WAYZATA PLANNING COMMISSION

Meeting Agenda

MEETING DATE: June 20, 2022	AGENDA ITEM: 5.a
TITLE: Consider Development Application for Wayzata Gateway at 900 Wayzata Boulevard East	
PREPARED BY: Valerie Quarles, Assistant Planner	
REVIEWED BY: Emily Goellner, Community Development Director	
60 DAY DEADLINE: August 1, 2022

**Staff Report
Wayzata Planning Commission
June 20, 2022**

C4.2

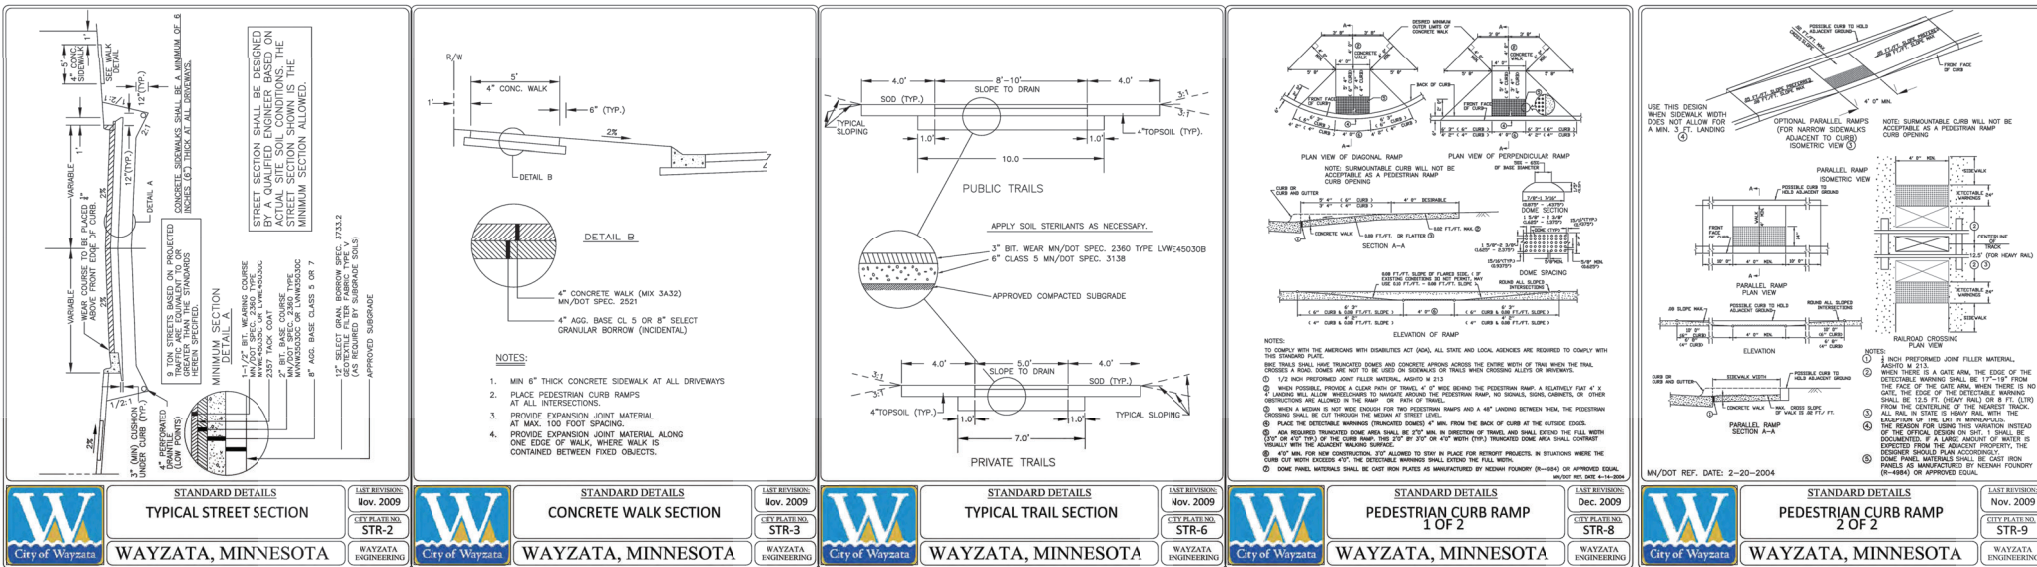
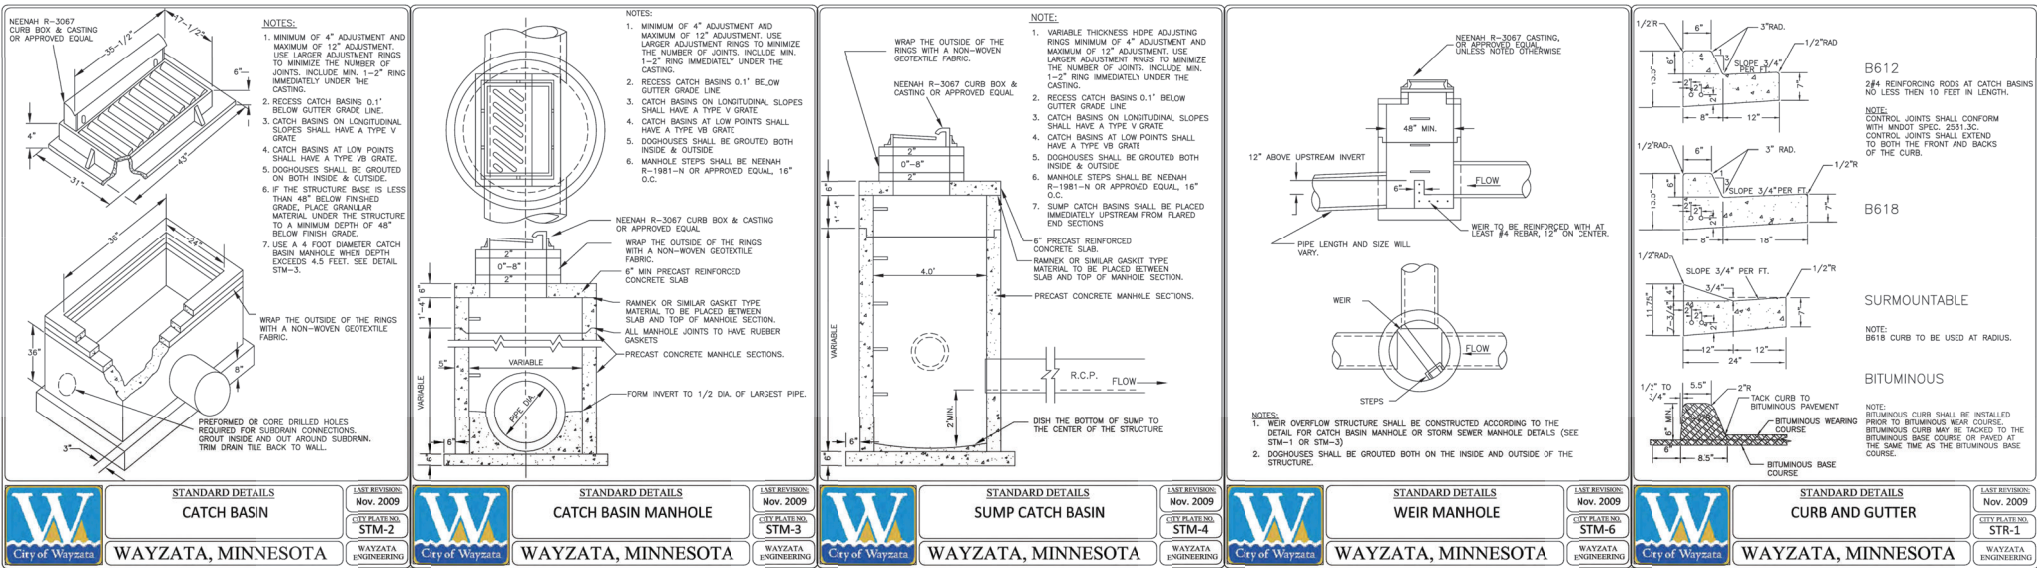
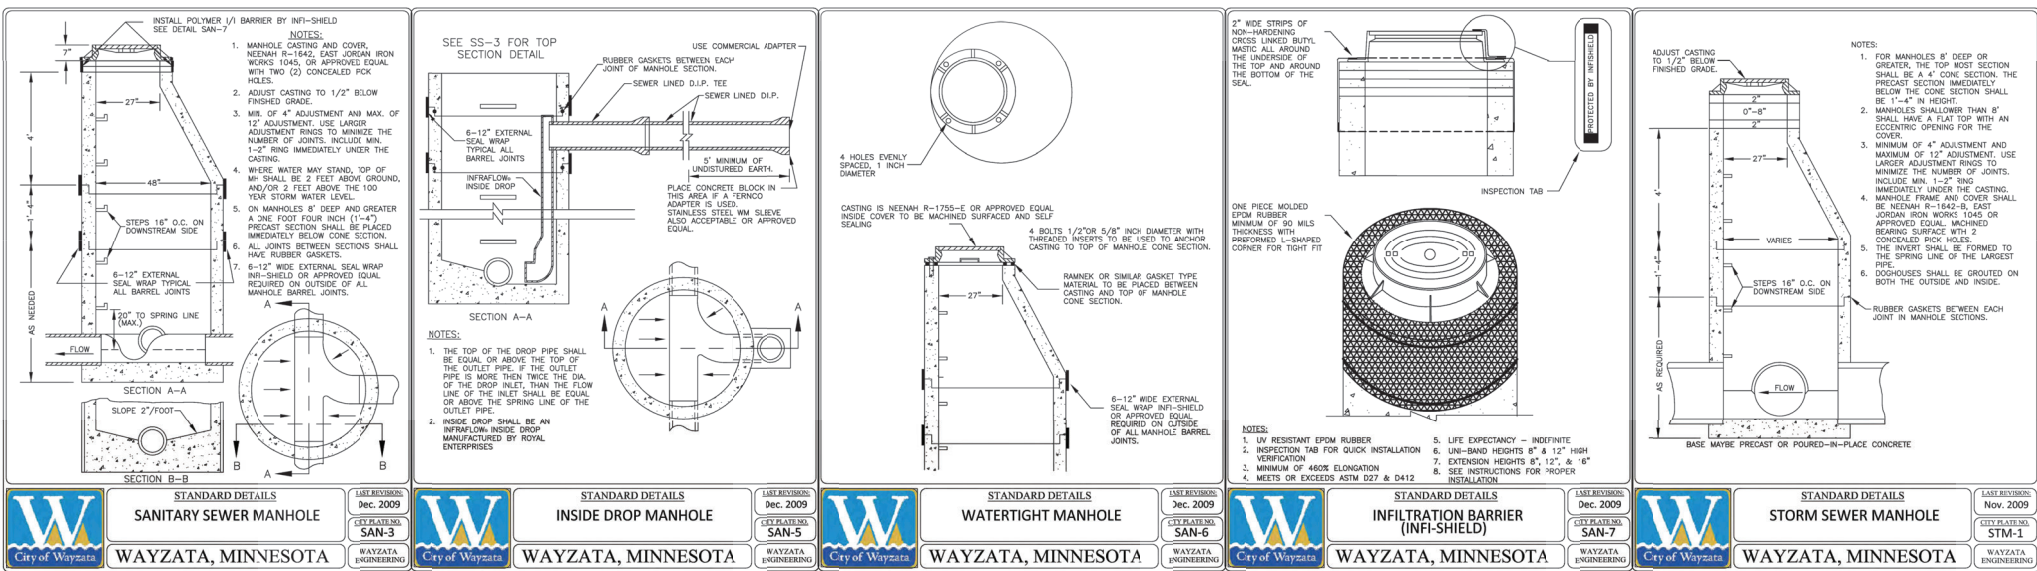
14. *Sheet C4.2 – Sanitary & Watermain Utility Plan, Stantec is evaluating the project's impact on the City's existing water, sewer and lift station #24 infrastructure. Comments to follow, via formal Stantec memo.*

15. *Sheet C4.2 – Sanitary & Watermain Utility Plan, If project is approved, plans and profiles shall be submitted for review and approval.*

Figure 7 - 2025 Build Volumes

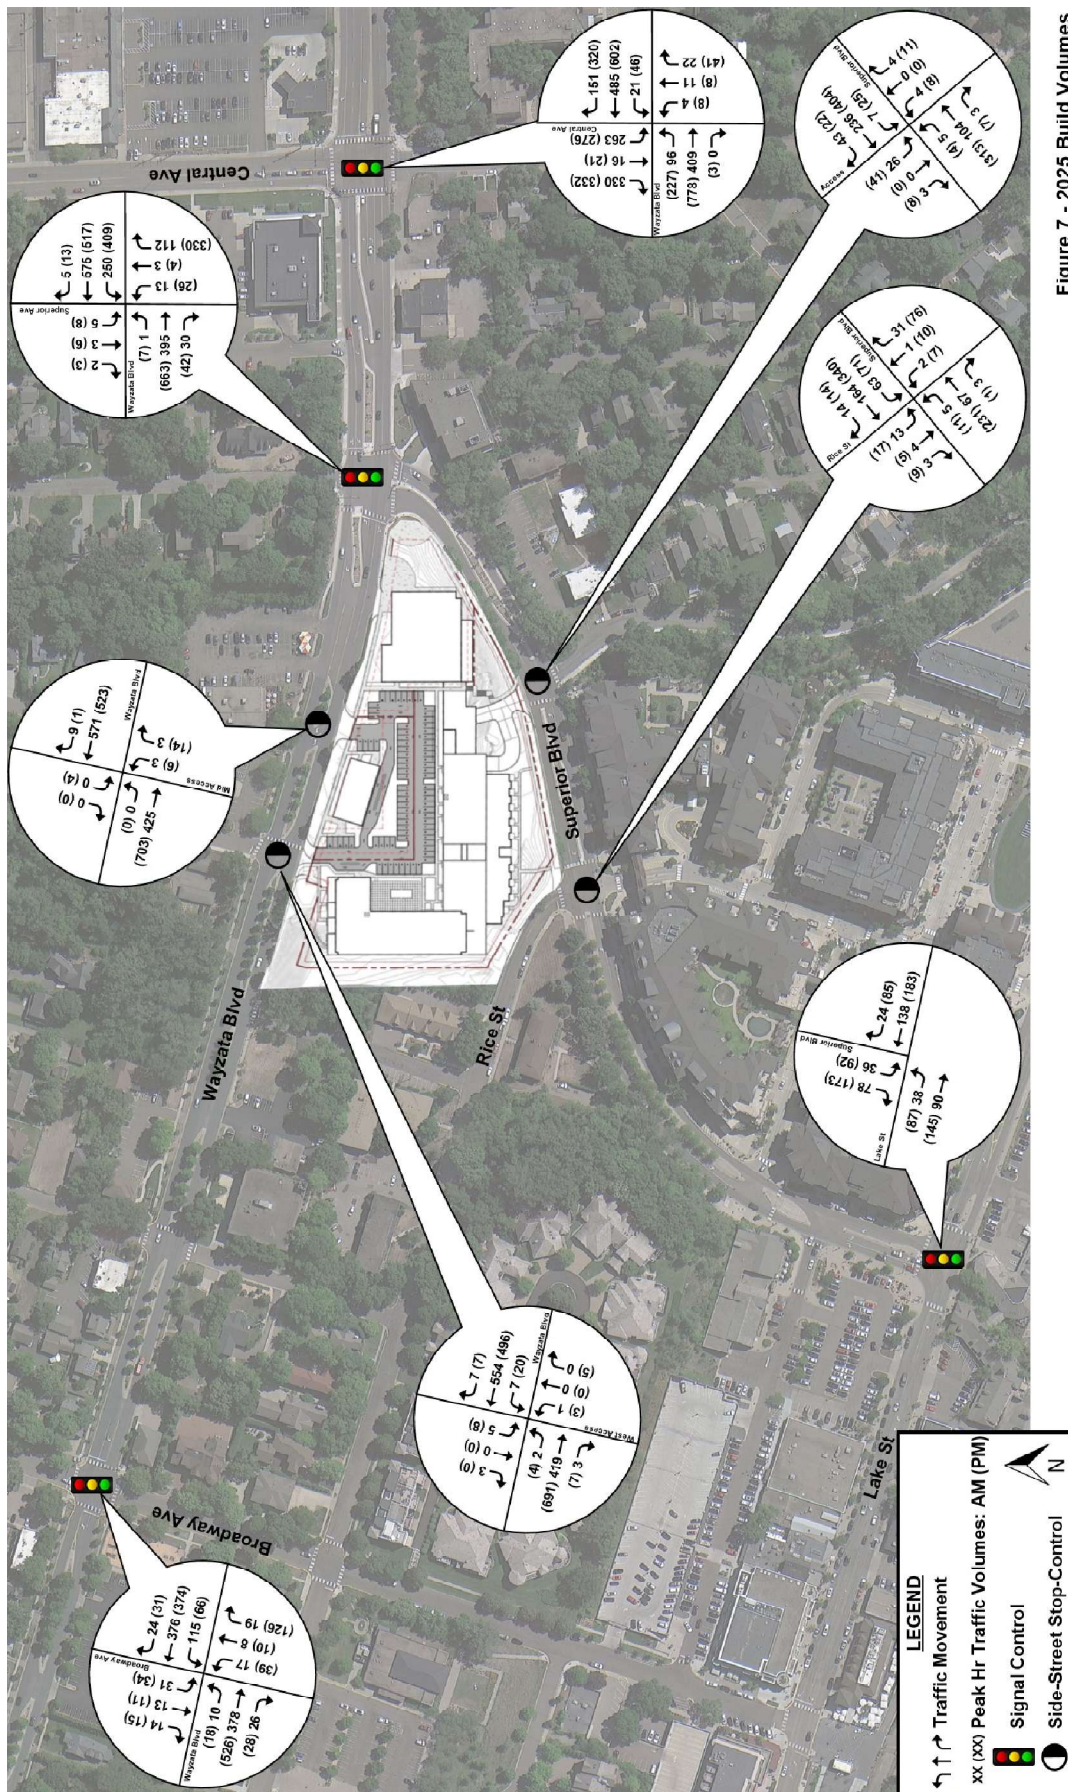
9. The distribution used for trips to/from the proposed development appears to be consistent with roadway travel patterns.
10. In Figure 7 Year 2025 Build Conditions, the Wayzata Boulevard entering/exiting volumes are incorrect and do not match the trip generation table. The Superior Boulevard access volumes are correct for the entering/exiting for the office and residential uses.
11. **The Wayzata Boulevard accesses indicate 13 entering and 7 exiting trips during the a.m. peak hour when it should be 10 entering and 7 exiting. During the p.m. peak hour, the Wayzata Boulevard accesses indicate 59 entering and 56 exiting trips when it should be 27 entering and 28 exiting based on the trip generation for the development.**

15. The conclusions are accurate, however the volumes should be updated along Wayzata Boulevard to accurately reflect the volumes for the site. Given that the volumes that were shown in Figure 7 for the year 2025 build conditions are higher than what is expected for the site, the results are conservative and the intersections would still be expected to operate acceptably with the modified, correct volumes.
